# KENWOOD

SB-959

## SERVICE BULLETIN

SUBJECT	DATE										
TS-950SD SPEECH PROCESSOR NOISE	01/12/90										
<p>When the Processor-In control is set to some level below 10dB of compression, a crackling noise can be induced on the transmit signal. The following modification will reduce the noise. After the modification has been performed, the noise can only be heard when the Processor-In control is set too low to be functional.</p>											
<p>NOTE: This modification has already been performed on models starting with serial number 0120441.</p>											
<p>REQUIRED PARTS:</p>

ORIGINAL

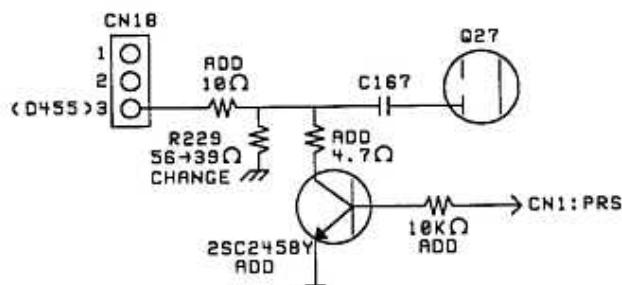
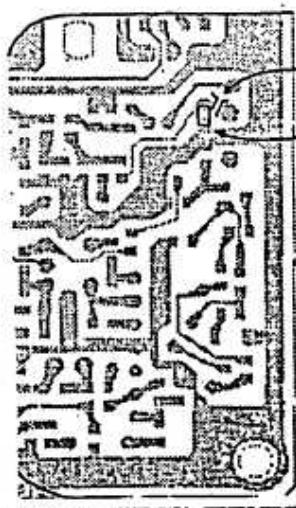
5. Solder a 4.7 ohm resistor to the collector of a 2SC2458(Y) transistor. Shorten the lead length to accommodate the following installation and insulate the leads with shrink tubing.
6. Solder the exposed end of the 4.7 ohm resistor to chip capacitor C167.
7. Solder the base and emitter leads as shown in the accompanying diagram.
8. Solder a 10K ohm resistor to the circuit as shown.

REMOVE  
R229

ADD 10 OHM  
INSTALL R229

ADD 4.7 OHM  
W4

ADD 10K OHM  
ADD 2SC2458Y

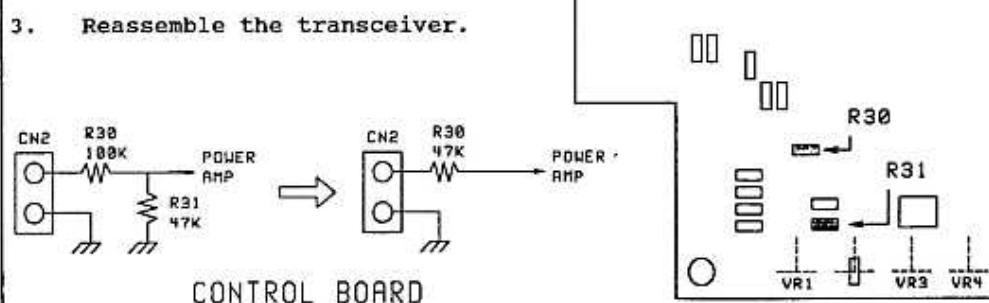
1. Desolder and discard chip resistors R30 and R31.
2. Install a 47K ohm chip resistor in place of R30. Do not use R31 (47K ohm) in the R30 position. Use a new resistor.
3. Reassemble the transceiver.

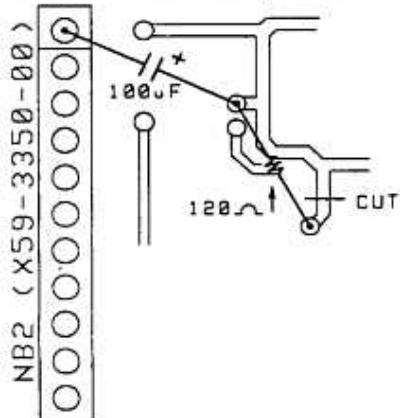
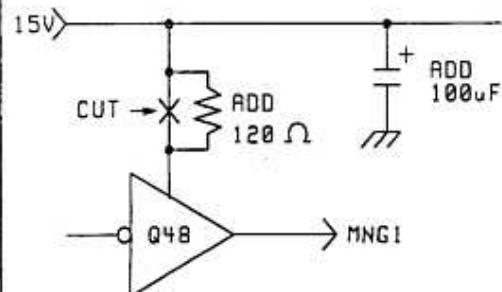
1. Cut the foil as shown in the accompanying diagram.
2. Add a 120 ohm resistor between the emitter of Q48 and the 15V line.
3. Add a 100uF, 16V capacitor between the 15V line and ground.

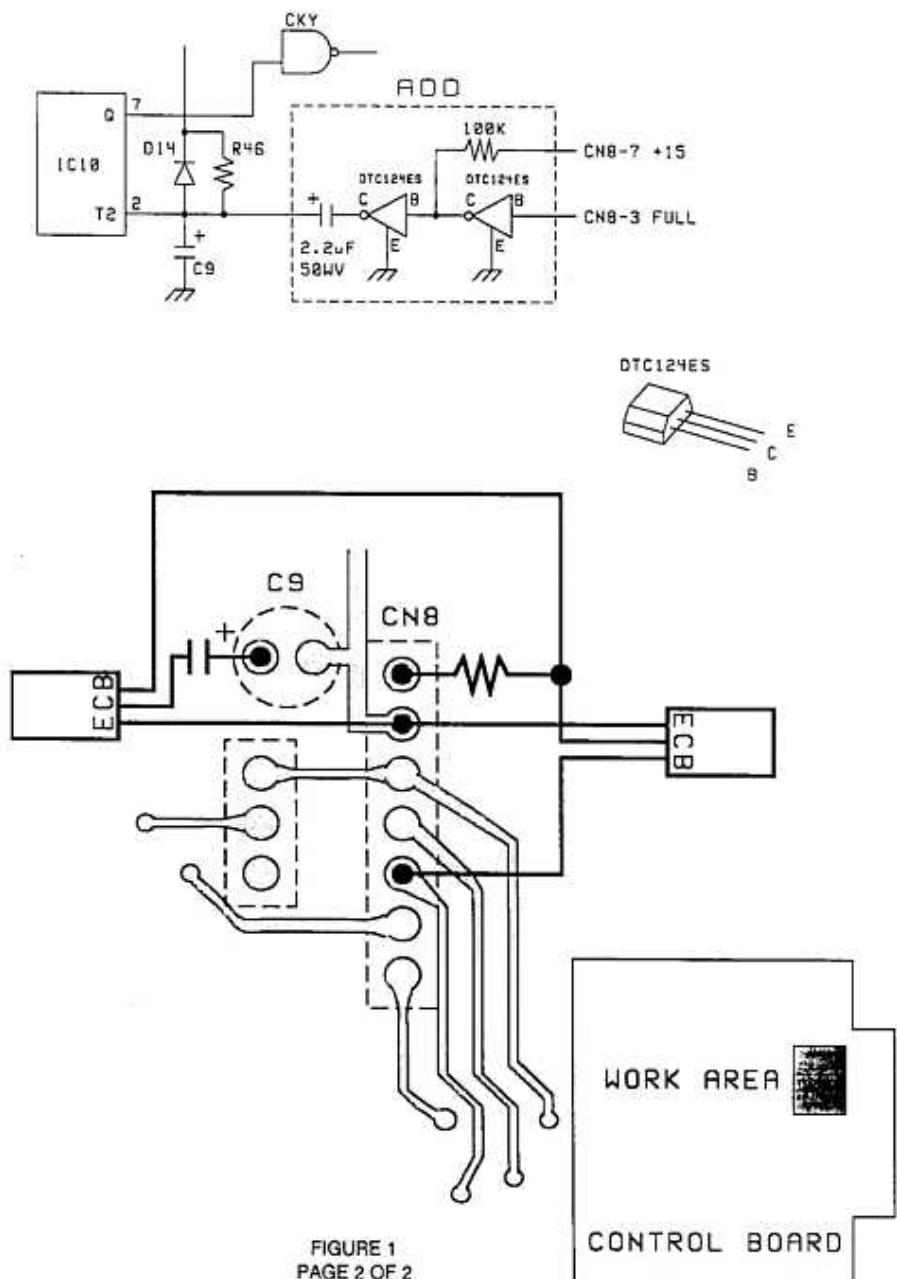
1. Disconnect the power cord and antenna.
2. Remove the top and bottom covers (18 screws).
3. Remove the top screw from each side of the front panel assembly.
4. Loosen the bottom screw on each side of the front panel assembly.
5. Pull the front panel assembly forward to expose the Digital and Control boards.
6. Remove the two screws that secure Control board B/3 to the top of the chassis and swing the board out of the way.
7. Remove the 4 screws from Control board A/3 and rotate the board down. Disconnect the right hand plugs as necessary to expose the foil side of the Control board.
8. Install the circuit shown in figure 1 on the foil side of Control Board A/3.
9. Assemble the transceiver by reversing steps 1 - 7.

FIGURE 1

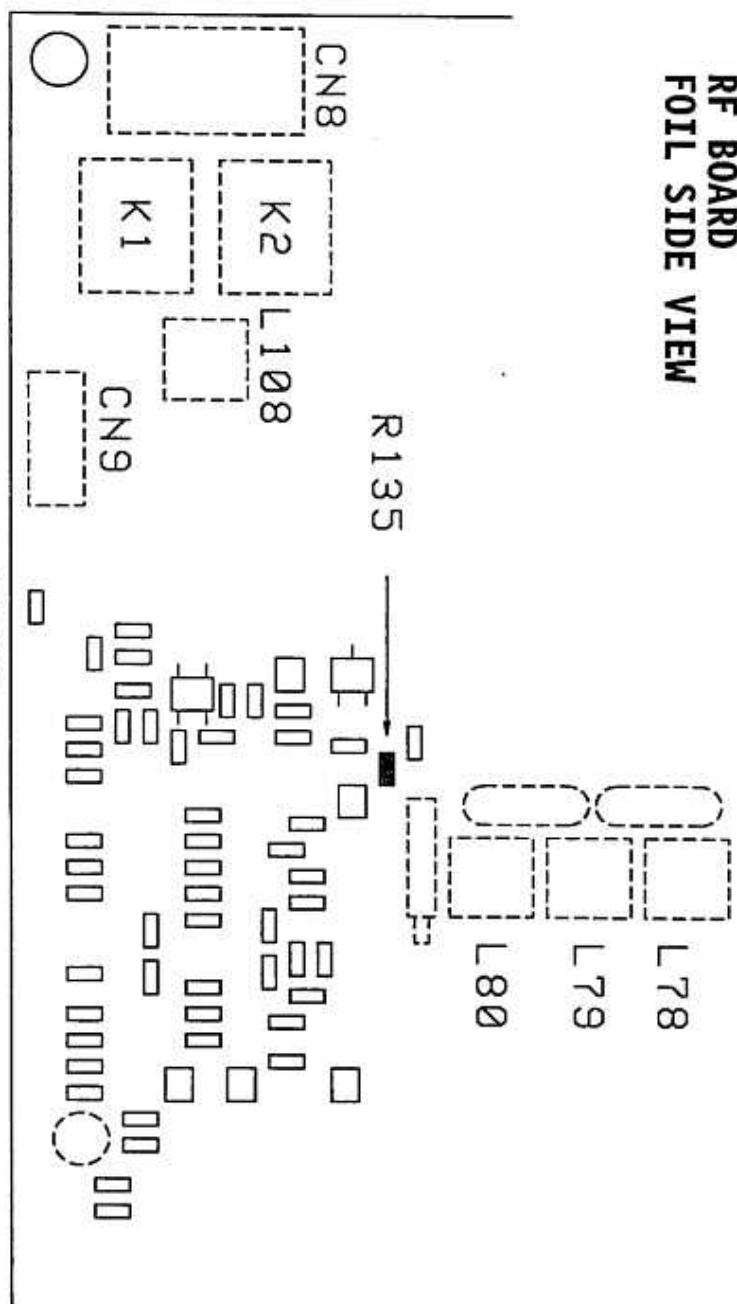
1. Disconnect the power cord and antenna.
2. Remove the top and bottom covers (18 screws).
3. Locate the RF unit on the bottom of the transceiver. This is the back left board of the four boards on the bottom of the transceiver.
4. Remove the RF board shield plate (4 screws).
5. Remove the 3 remaining screws from the RF board.
6. Remove the black screw that secures the DRIVE OUT/RX ANT IN jack to the back panel.
7. Disconnect the right hand coax cables from the RF board and unplug connector #2.
8. Slide the RF board forward and then rotate it towards the front of the transceiver to expose the foil side of the board.
9. Locate chip resistor R135 as shown in figure 1.
10. Replace R135 with a 2.2K ohm chip resistor.
11. Assemble the transceiver by reversing steps 1 - 8.

AF UNIT X49-3020-00

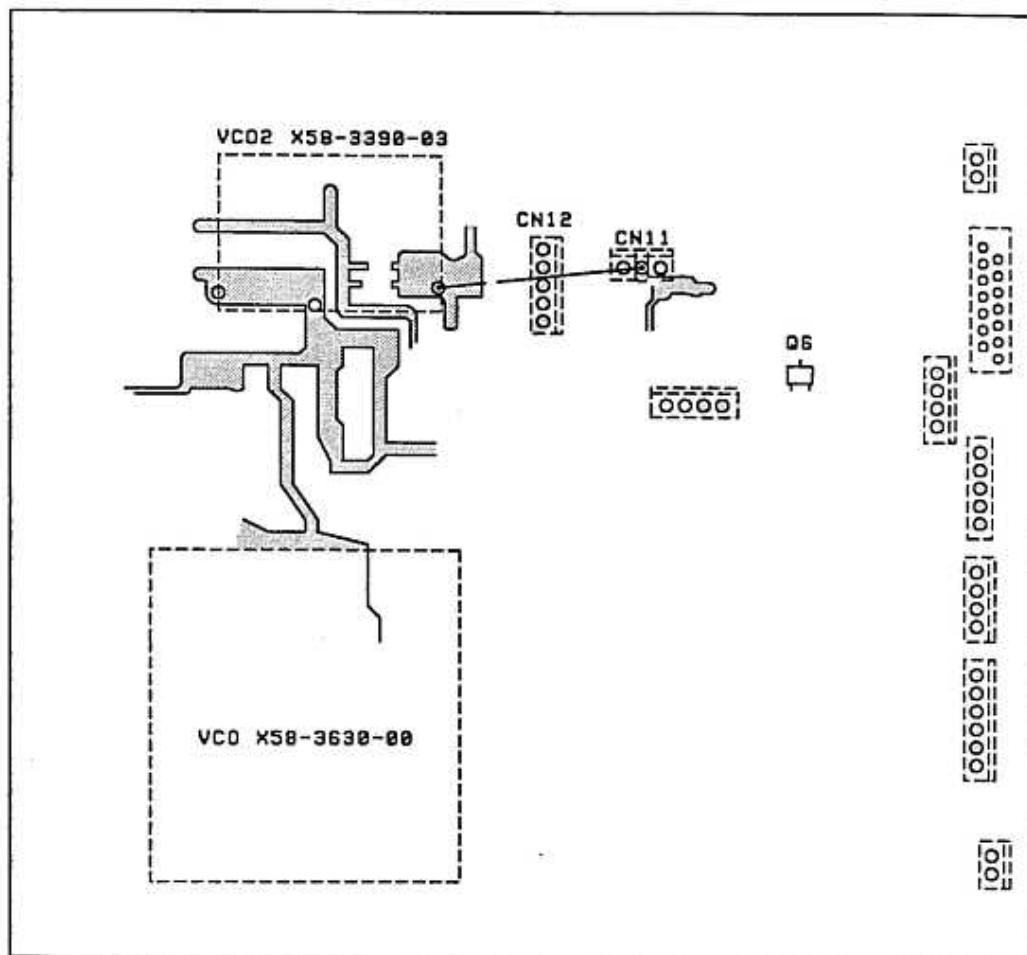
1. Disconnect the power cord and antenna.
2. Remove the top and bottom covers (18 screws).
3. Locate the AF unit on the bottom of the transceiver. This is the front left board of the four boards on the bottom of the transceiver.
4. Remove the screws from the AF unit and disconnect the plugs as necessary to turn the board over to expose the foil side of the board.
5. Replace Q6 with a 2SD1757K(S).
6. Solder a 22 AWG jumper wire as shown in figure 1.

FIGURE 1

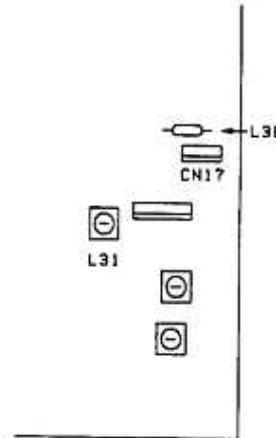
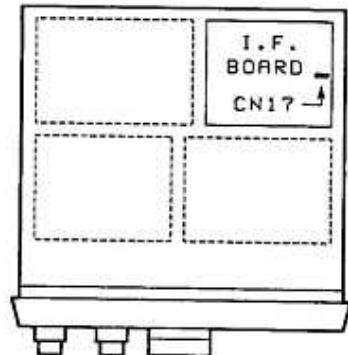
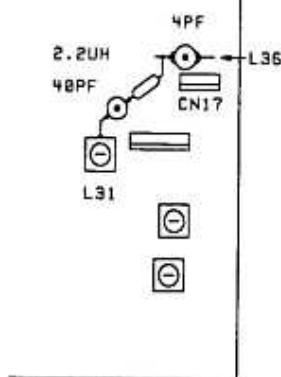
1. Disconnect the power cord and antenna.
2. Remove the top and bottom covers (18 screws).
3. Locate the I.F. board on the bottom of the transceiver. This is the back right board of the 4 boards on the bottom of the transceiver. Figure 1
4. Locate L36 by connector CN17 on the I.F. board. Figure 2
5. Install and solder into place a 4pF trimmer capacitor across L36. Figure 3
6. Install a 2.2uH coil and 40pF trimmer capacitor in series from the output of L36 to ground. The can of L31 can be used for ground. Figure 3

FIGURE 1

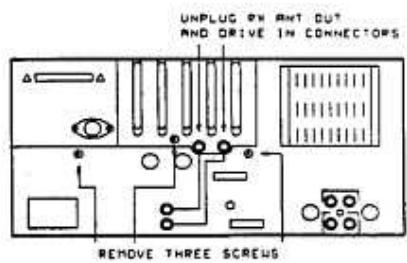
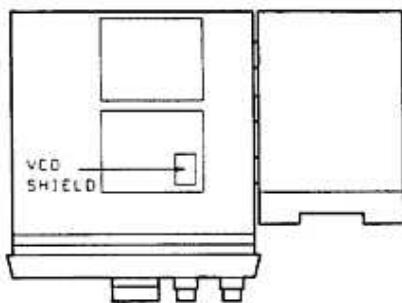
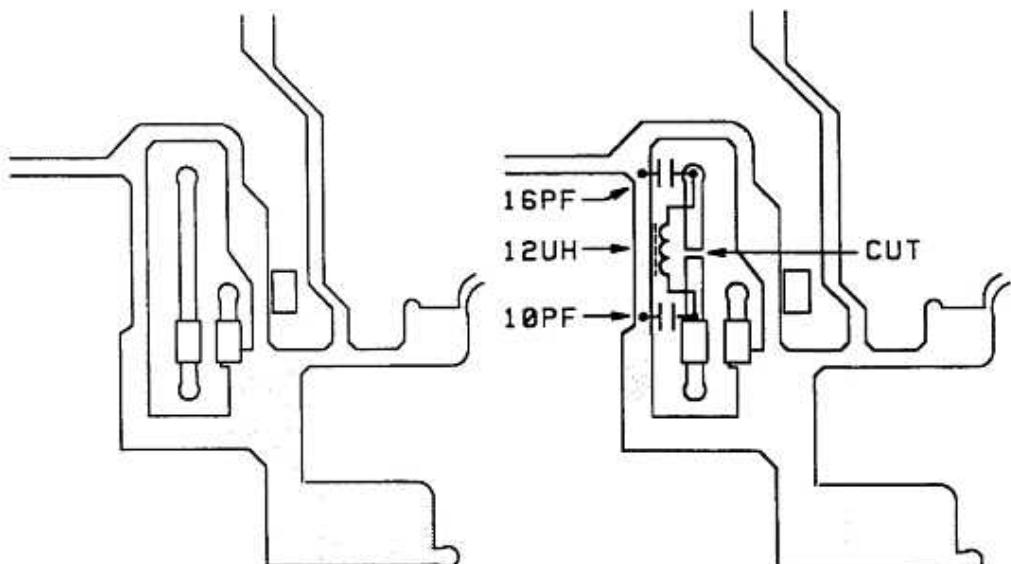
1. Disconnect the power cord and antenna.
2. Remove the top and bottom covers (18 screws).
3. Open the subchassis to expose the PLL board (Figures 1-3). To open the subchassis remove 4 top screws, remove 3 back panel screws, and unplug the RX ANT OUT and DRIVE IN connectors.
4. Replace the four VCO shield plate screws with the type listed above. Figure 3
5. Close the subchassis and secure it with the screws removed in step 3.
6. Locate the A.F. board on the bottom of the transceiver. Figure 4
7. Remove the board's mounting screws and disconnect the necessary connectors to expose the bottom of the board.
8. Locate the foil pattern area shown in Figure 5. This area is below IC11.
9. Cut the foil pattern and add the components shown in Figure 6.
10. Assemble the transceiver. Remember to plug in the two connectors on the back panel.

AF Unit (X49-3020-00)  
Foil Side View

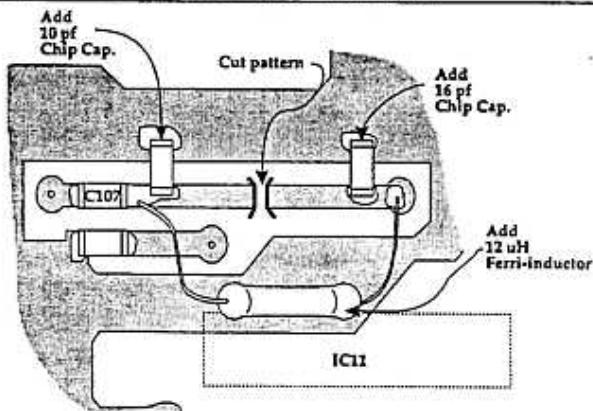
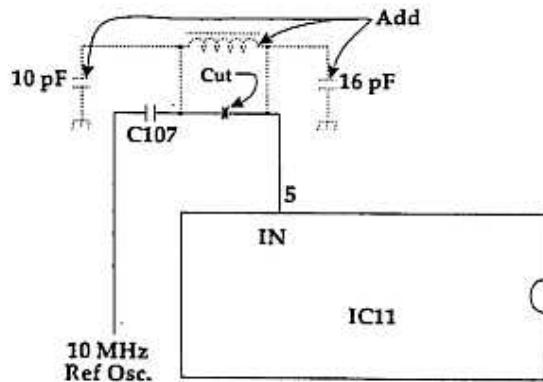
The transmitted signal enters pin 5 of IC11 which is in the last PLL loop in the AF unit due to RF feedback. This pin is the input for the 10 MHz Ref Osc signal from the CAR unit. IC11 is the source of the spurious signal since both the band and 10 MHz frequencies are divided by the 500 kHz comparison frequency supplied by IC11.

To reduce this RF feedback increase the Ref Osc level from .2V to .7V rms by adding the accompanying circuit to the input of IC11.
